SERVICE BULLETIN

from: TRIO-KENWOOD COMMUNICATIONS, INC.

SUBJECT: TS-180S IF OUTPUT #2 LEVEL CHANGE FOR
SM-220 OPERATION

DATE 7/10/79

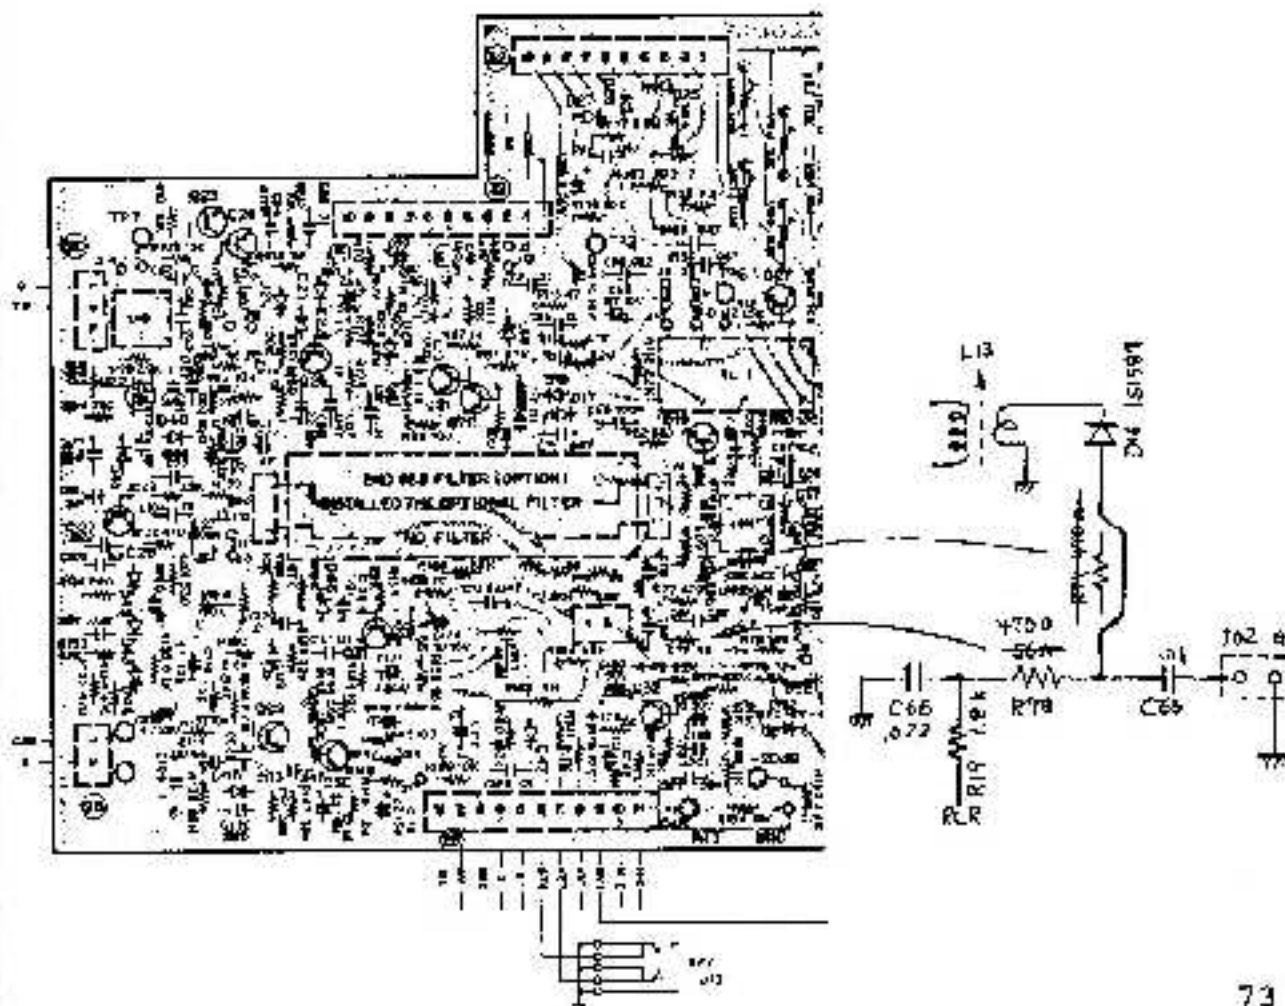
TS-180S owners who desire to operate an SM-220 for IF output display will require a wiring change to the IF unit X48-1240-00. No additional parts and no adjustments are required.

Remove R77, 470 ohm, and replace with wire jumper. Remove R78, 56 ohm, and replace with old R77. The 56 ohm resistor is not used.

With AGC on, gain should be adequate for about a 3/4 screen display.
